# BCA Capability Statement

The Junction Project  
Cnr Kendrick Street, The Junction NSW 2291

**Prepared for:**  
Diverse Property Group

**Revision 1**  
08 May 2026  
Reference: N260002

Figure 2

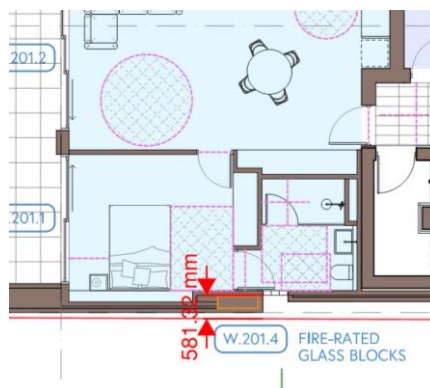
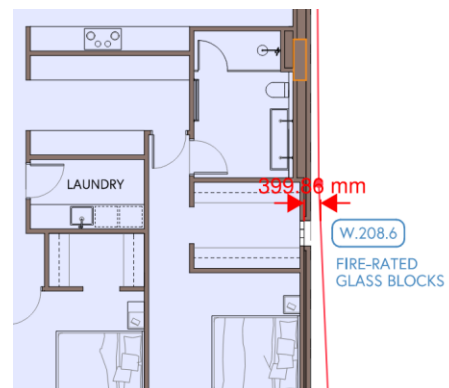
**Comment:** Compliance is readily achievable. Where openings in the external wall are located less than 3m from the side and rear allotment boundaries, protection is required in accordance with these clauses. Based on the current design, fire rated glass blocks are proposed to be used where exposed to the side allotment boundaries on the Class 2 levels, as shown in the figures below.

Details demonstrating compliance are to be included in the window schedule provided at Construction Certificate stage.

Figure 4: Indicative Markup of Exposure

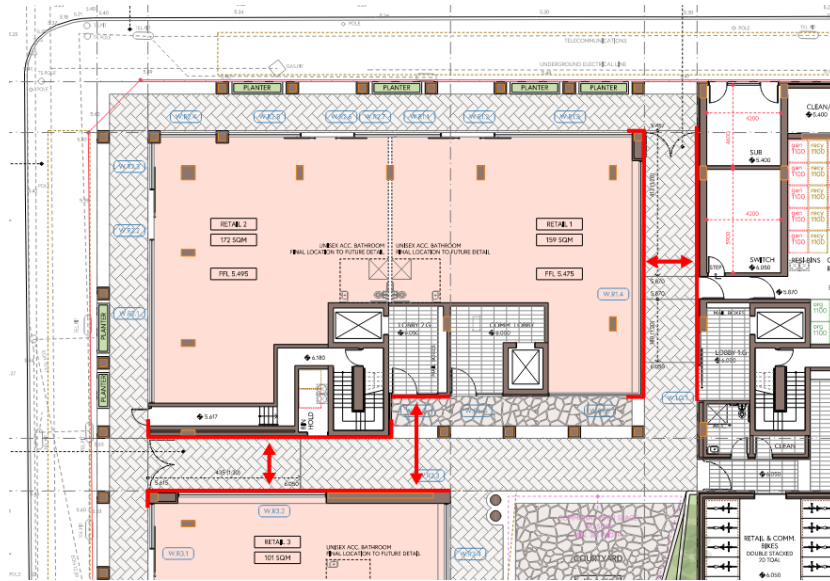
**Comment:** Protection to the external walls and associated openings are to be protected where highlighted in the figure below where exposure occur between different fire compartments within the building. Details are to be provided to confirming adequate protection is proposed at Construction Certificate stage.

Where the fire rating to the external walls and protection of the associated openings are proposed to be reduced, this is to be addressed by way of a fire engineered strategy.

Figure 5: Bounding Construction of Lobby 2.6

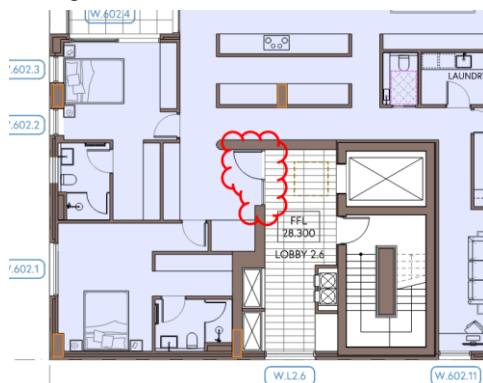
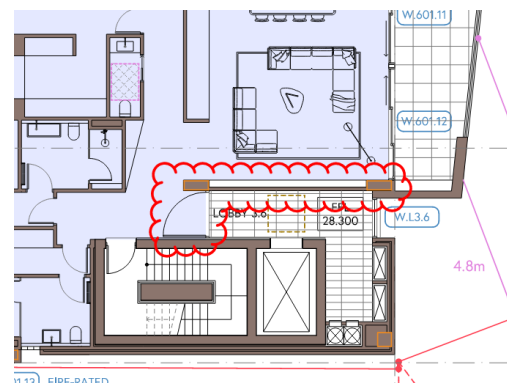
**Comment:** Further details demonstrating compliance with the requirements of this clause are to be included in the architectural documentation where 60 minute separation is proposed to be achieved. Where the FRL of bounding construction between a Class 2 SOU and the public corridor is proposed to be reduced below -/60/60 as required by C2D2, this is to be addressed by way of a fire engineering strategy to permit be smoke separated in lieu of being provided with fire rated bounding construction.

Figure 7: Typical Available Exit Locations – Basement Levels

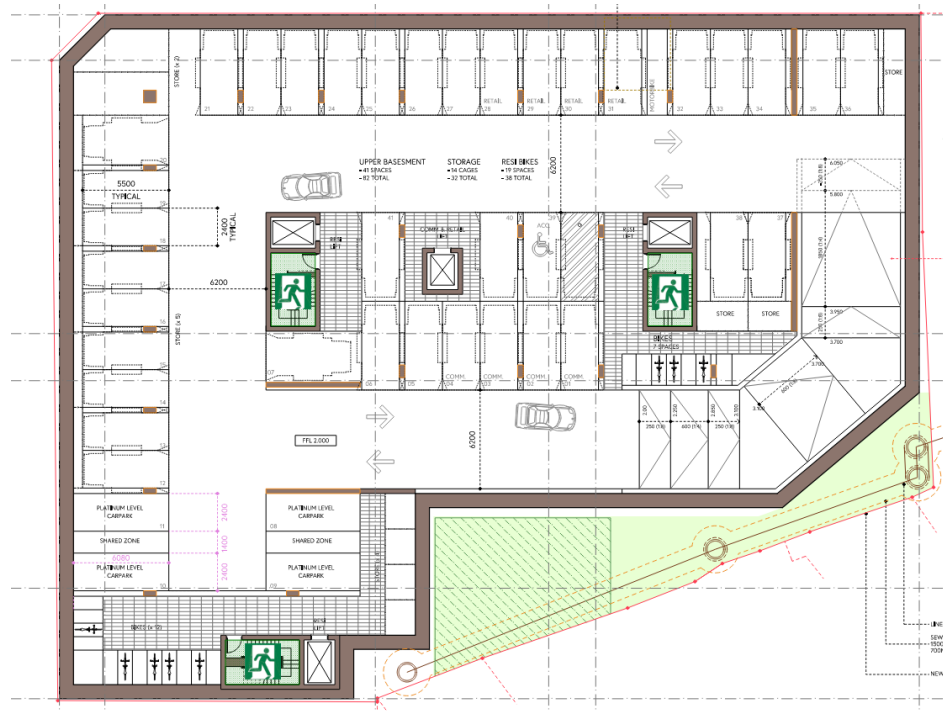
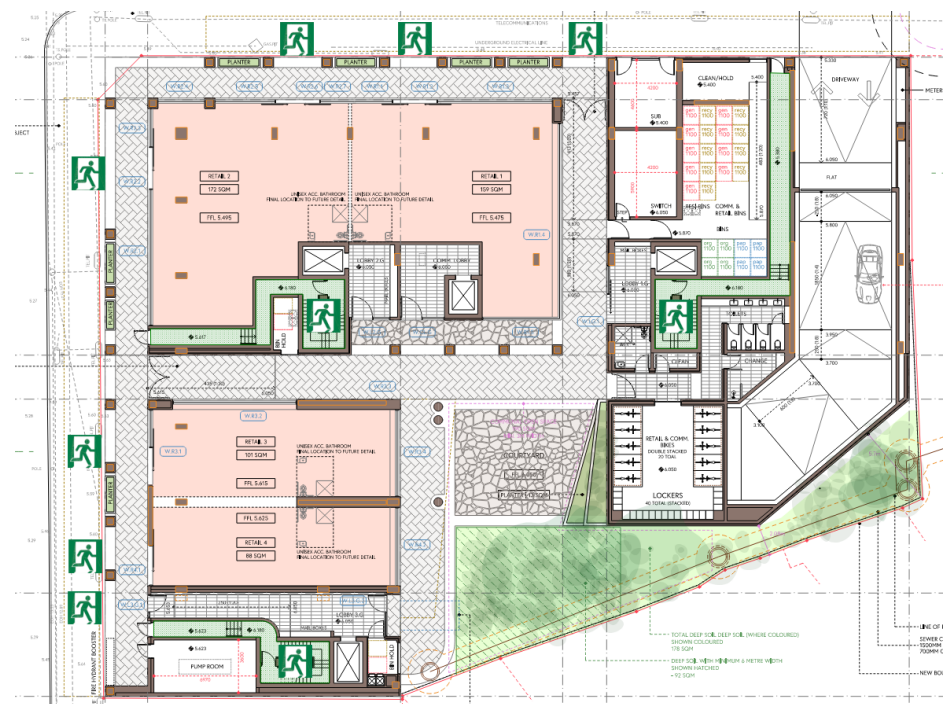
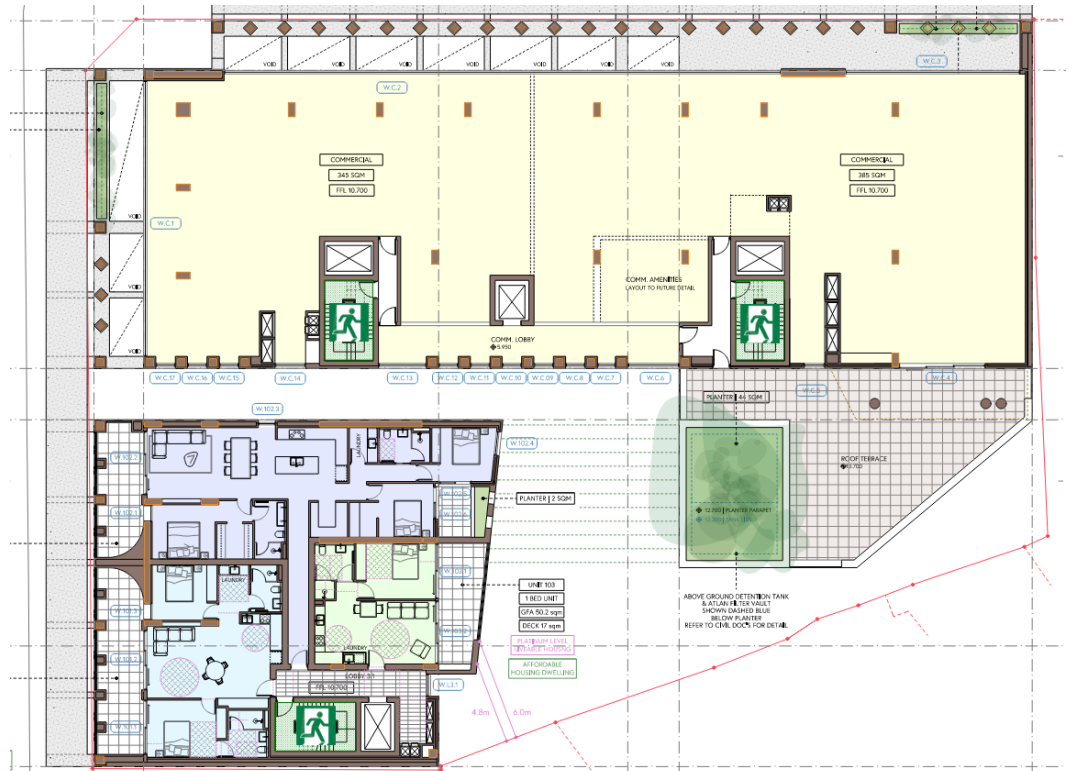
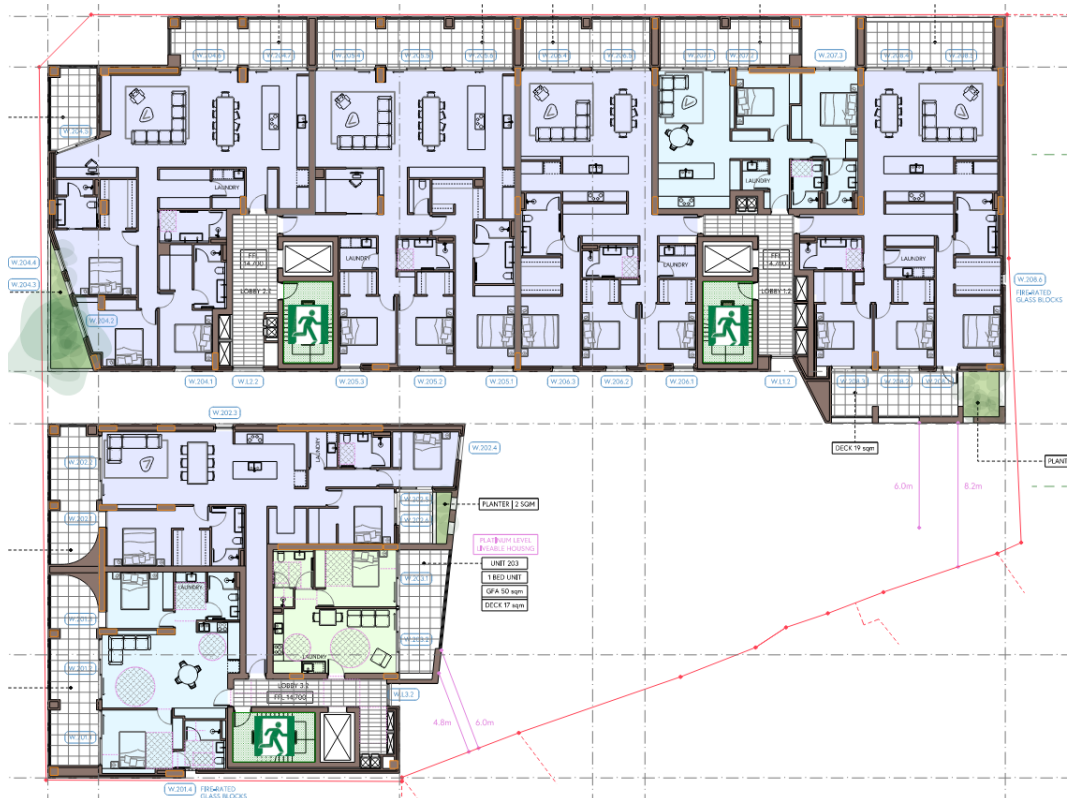
**Comment:** Compliance is readily achieved. The number of exits provided to each storey and area of the building complies with the requirements of this clause. See typical locations of available exit in the figures below.

Figure 11: Extended Path of Travel – Level 1

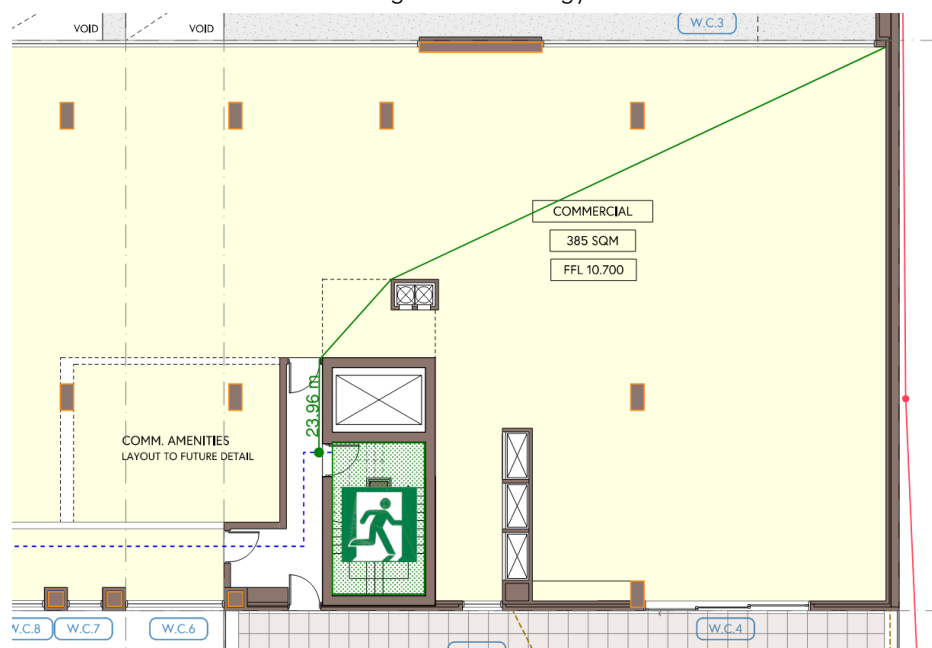
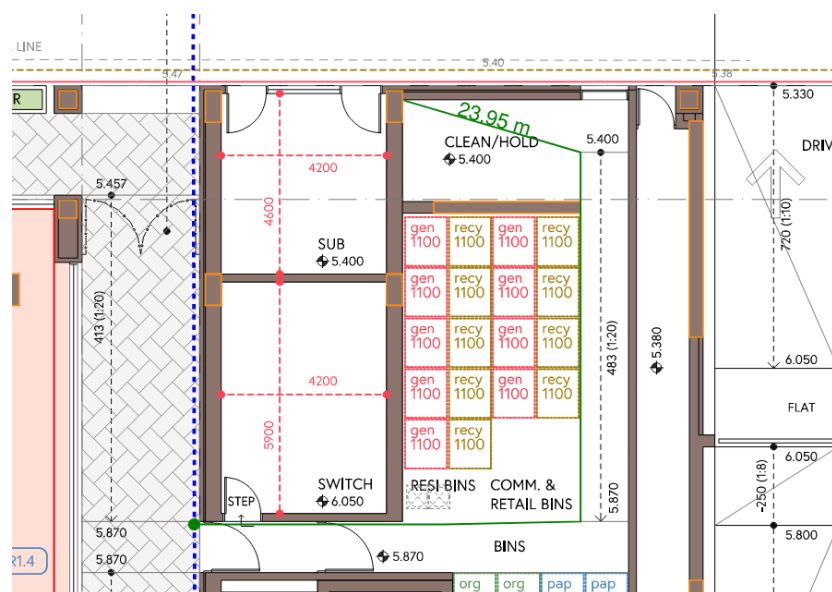
**Comment:** Compliance appears to be achieved throughout the majority of the building except where shown in the figure below. The extended path of travel from the Level 1 Commercial and the Ground Floor Clean Room to the point of choice between alternative exits is to be not greater than 20m or else be address via a fire engineered strategy.

Figure 13

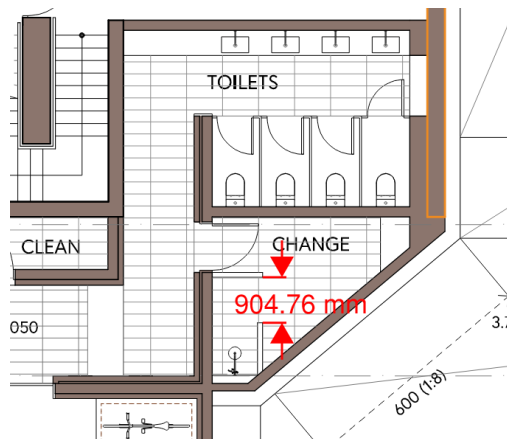
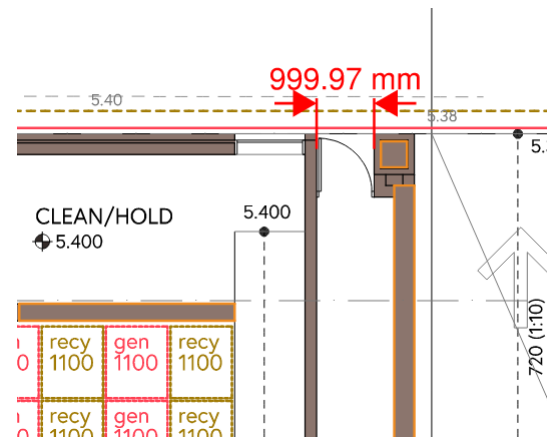
**Comment:** Reduced widths are to be amended within the design where clearance unobstructed widths measures to be less than 1000mm. Typical examples of reduced clearances widths are shown in the figures below.

The architect is to review and amend egress widths throughout and is to monitor compliance through design development.

Figure 15

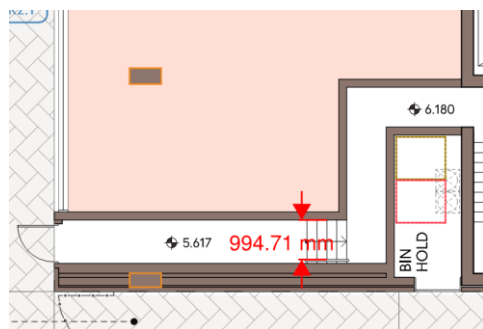
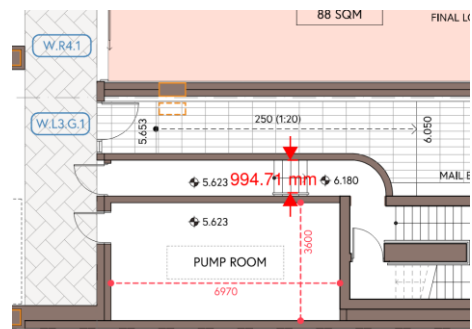
Additional width and construction tolerances are to be provided within the fire isolated exits, especially where the stair ways are provided with required handrails. Typical examples are shown in the figures below.

Figure 17: Fire-Isolated Exits Discharging to Non-Compliant Covered Area

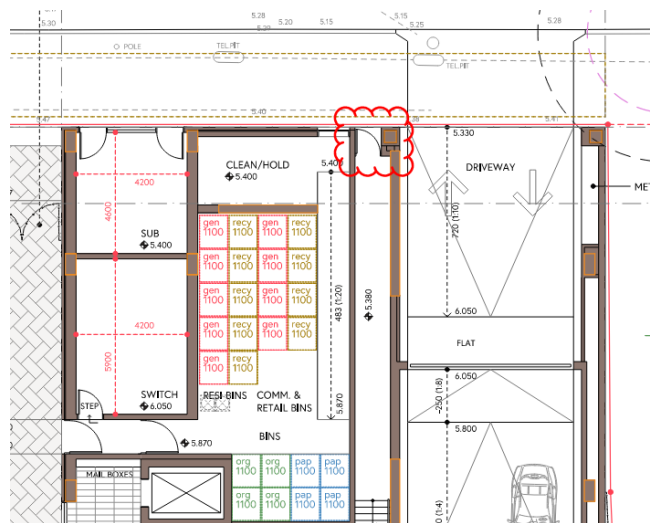
**Comment:** The northern eastern fire-isolated exit appears to discharge into a covered area where less than 1/3 of the perimeter is open. It is unclear whether the minimum required 3m height clearance is achieved within these spaces. The design is to be amended to achieved compliance with the requirements of this clause or else this is to be addressed via a Fire Engineered Strategy.

Figure 18: Typical Example of Direct Connection between Stairs

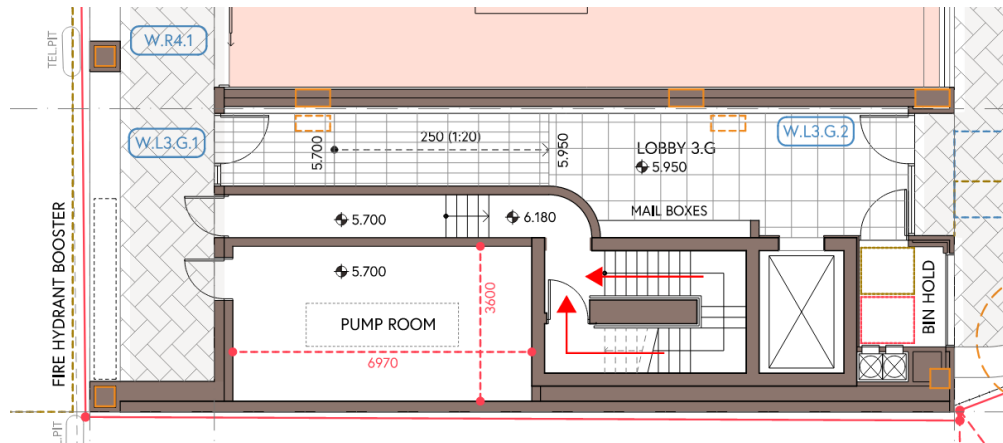
**Comment:** The current arrangement includes a direct connection between the rising and descending stairs from the basement levels and above ground level respectively. It is understood the combined use of the single passage by the rising and descending stairs with be rationalised via a fire engineered strategy.

Figure 19: Building Section

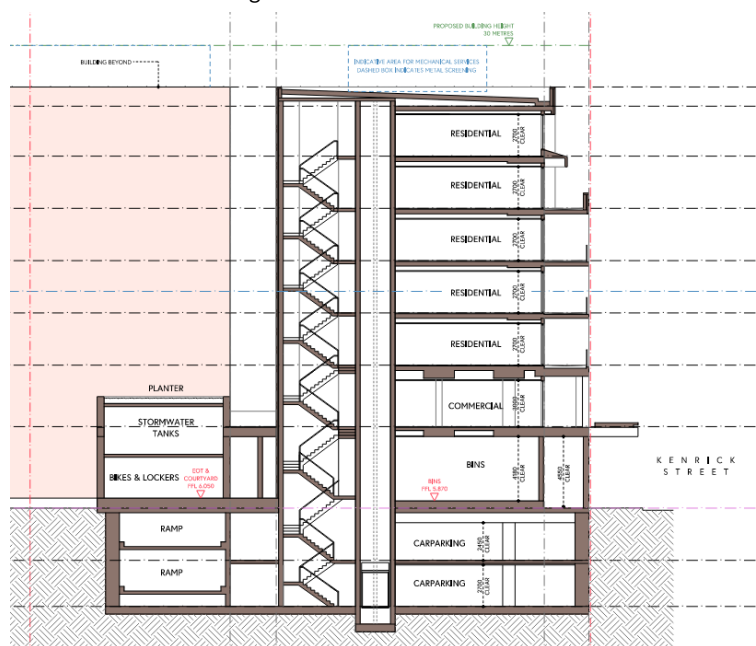
**Comment:** Compliance is Readily Achievable. Based on sections provided, complaint clearance heights appear to be achieved throughout.
